UNITED STATES PATENT AND TRADEMARK OFFICE

APPLICATION NO.	FILING DATE	FIRST NAMED INVENTOR	ATTORNEY DOCKET NO.	CONFIRMATION NO.
10/645,870	08/22/2003	Tetsuya Uda	62807-137	8647
20277	7590	04/19/2005	EXAMINER	
MCDERMOTT WILL & EMERY LLP 600 13TH STREET, N.W. WASHINGTON, DC 20005-3096			ROJAS, OMAR R	
			ART UNIT	PAPER NUMBER
			2874

Office Action Summary

DETAILED ACTION

Matsuoka discloses in Figure 4 (reproduced below) an optical transmission apparatus for amplifying wavelength-division multiplexed light received from a first optical transmission line and supplying it to a second optical transmission line, comprising:

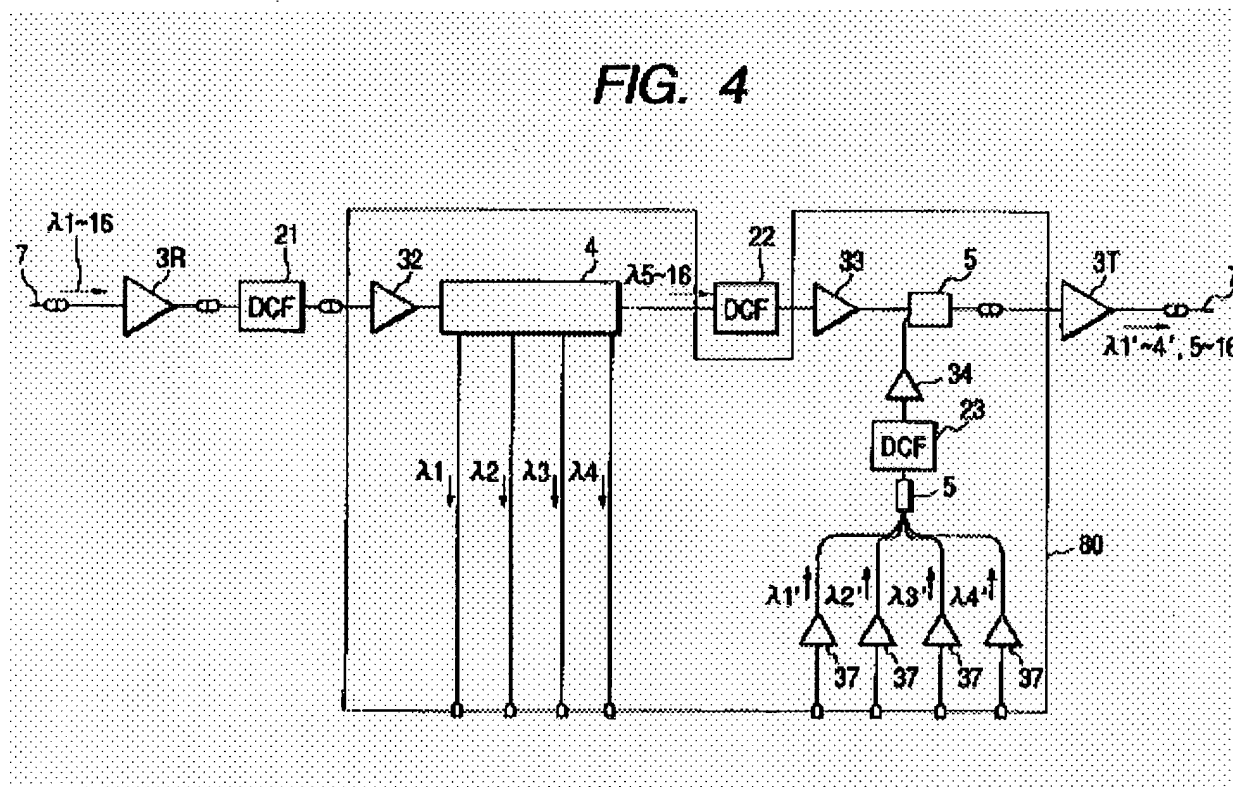
6. Claims 1, 4, 5, and 12 are rejected under 35 U.S.C. 102(b) as being clearly anticipated by Patent Publication 2001/0024544 to Matsuoka et al. (hereinafter “Matsuoka”).

- an optical amplifier (**3R, 3T**) for amplifying said wavelength-division multiplexed light;
- a first chromatic dispersion compensator **21** for compensating for chromatic dispersion caused during the transmission of said wavelength-division multiplexed light from a first predetermined position on said first optical transmission line to said optical transmission apparatus;

- and a second chromatic dispersion compensator (**22, 23**) for compensating for chromatic dispersion caused during the transmission of said wavelength-division multiplexed light between said optical transmission apparatus and a second predetermined position on said second optical transmission line.

Regarding claim 4, said optical amplifier includes a first optical amplifier **3R** provided between said first optical transmission line and said first chromatic dispersion compensator **21**, and a second optical amplifier **3T** provided between said second chromatic dispersion compensator **22** and said second optical transmission line.

Regarding claim 5, Matsuoka further teaches an add-drop portion **80**.

Regarding claim 1, Grasso shows in Figure 5 (reproduced below) an optical transmission apparatus for amplifying wavelength-division multiplexed light received from a first optical transmission line and supplying it to a second optical transmission line, comprising:

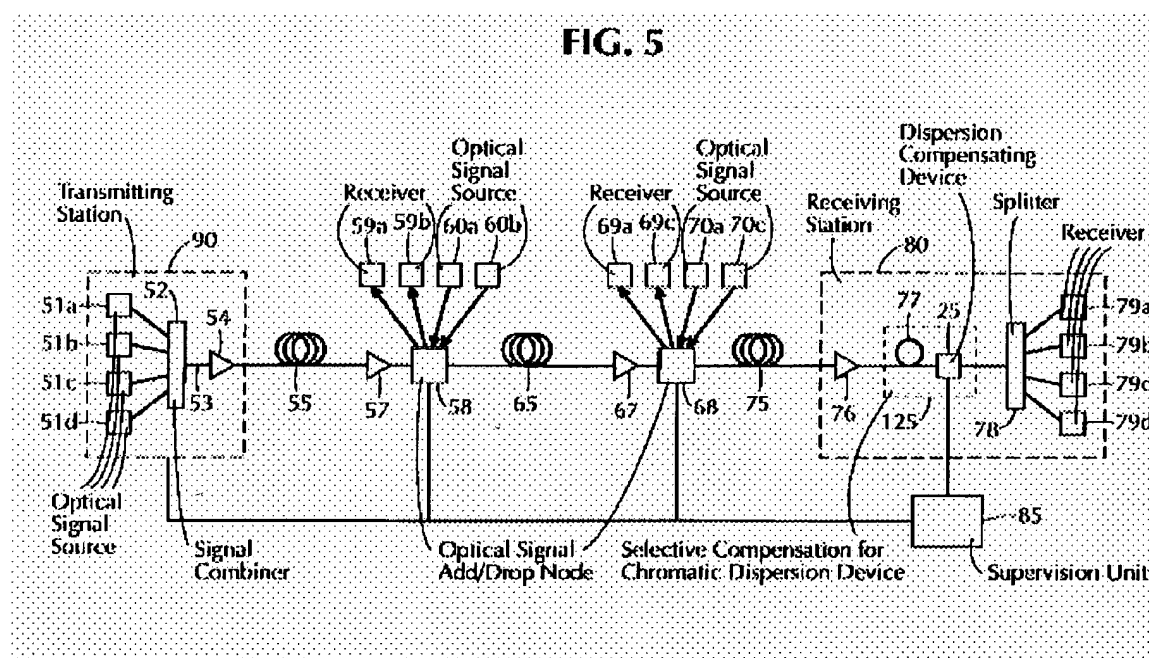
7. Claims 1-5 and 12 are rejected under 35 U.S.C. 102(b) as being clearly anticipated by Patent No. 5,943,151 to Grasso et al. (hereinafter "Grasso").

an optical amplifier **57** for amplifying said wavelength-division multiplexed light;

a first chromatic dispersion compensator (see **Figure 6 and column 16, lines 47-55**) for compensating for chromatic dispersion caused during the transmission of said wavelength-division multiplexed light from a first predetermined position on said first optical transmission line to said optical transmission apparatus;

and a second chromatic dispersion compensator (see **Figure 6 and column 16, lines 47-55**) for compensating for chromatic dispersion caused during the transmission of said wavelength-division multiplexed light between said optical transmission apparatus and a second predetermined position on said second optical transmission line.

Regarding claim 2, Grasso shows an add drop portion **58** between said first and second chromatic dispersion compensators, said add drop portion **58** having wavelength-dropping means for dropping an optical signal of a predetermined band from said wavelength-division multiplexed light, and wavelength-adding means for multiplexing an optical signal of a certain band with said wavelength-division multiplexed light.

Regarding claim 3, see Grasso at Figure 2 and column 15, lines 45-51. The add drop portion **58** of Grasso is implicitly detachable.

Regarding claim 4, said optical amplifier includes a first optical amplifier **57** provided between said first optical transmission line and said first chromatic dispersion compensator, and a second optical amplifier **67** provided between said second chromatic dispersion compensator and said second optical transmission line.
